**241 QUEEN ST E**  
**OZS-2023-0021**

Review by Sylvia Roberts

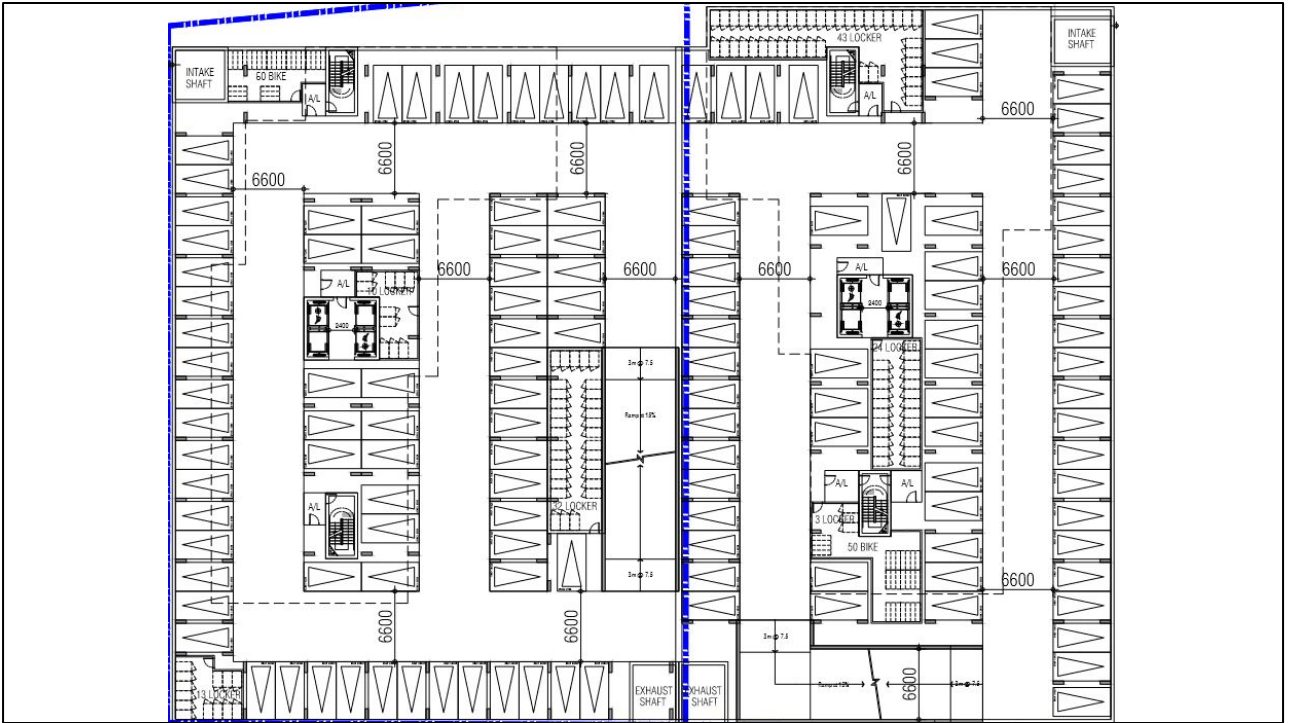
Can someone please explain why it references the City of Burlington, a GO Station or Walmart? I don't understand, this is in the City of Brampton.  
From Page 1 of architectural drawings

Here are floors P2-5 for Stage 1, nice, they included parking, just one problem...

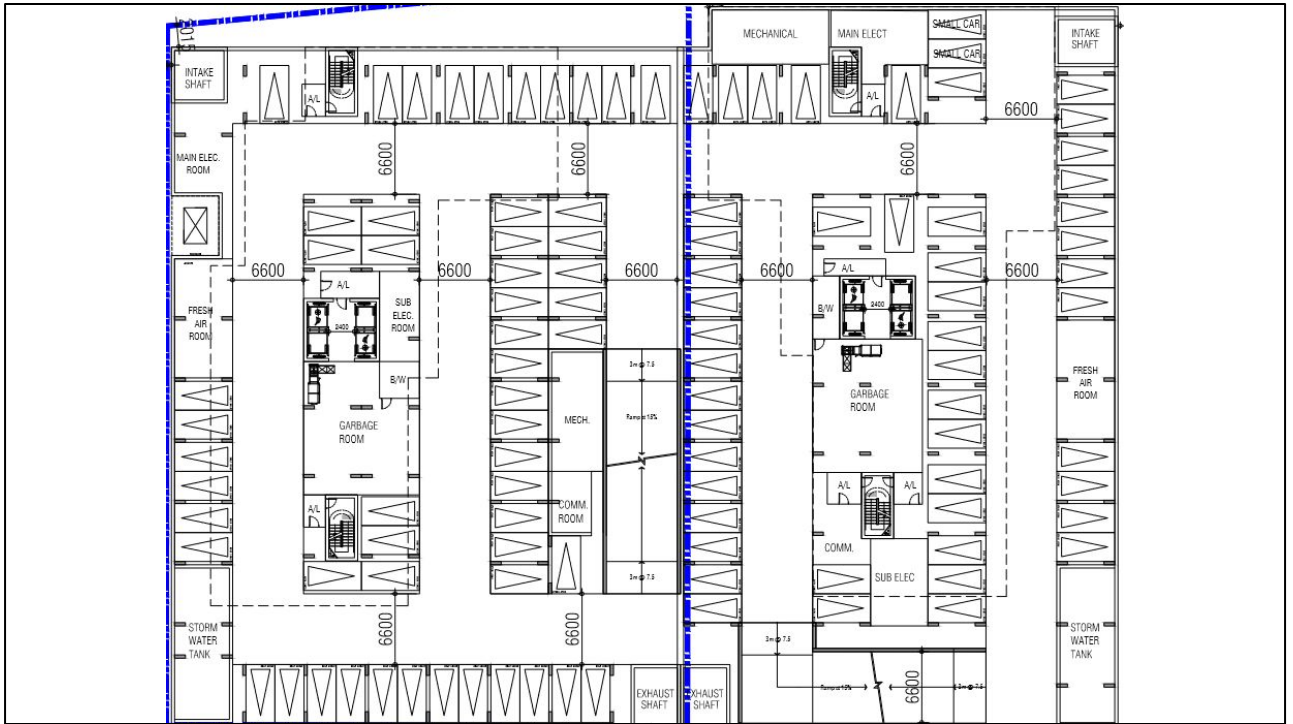
Said problem is P1 has no bike parking, this means in some cases people will need to either ride up up to five floors to get to the surface, or use the elevators, which can be slow, especially at peak times. I don't know how to ride a bike, but riding up 2-5 storeys sounds pretty tiring and impractical for regular usage. I strongly recommend the City working to get the bike parking on P1.

While not pictured, Phase 2 has the exact same issue of bike parking on P2-P5 but not P1. Phase 3 the office building lacks bike parking, despite the underground parking garage being bigger than the above ground portion of the building.
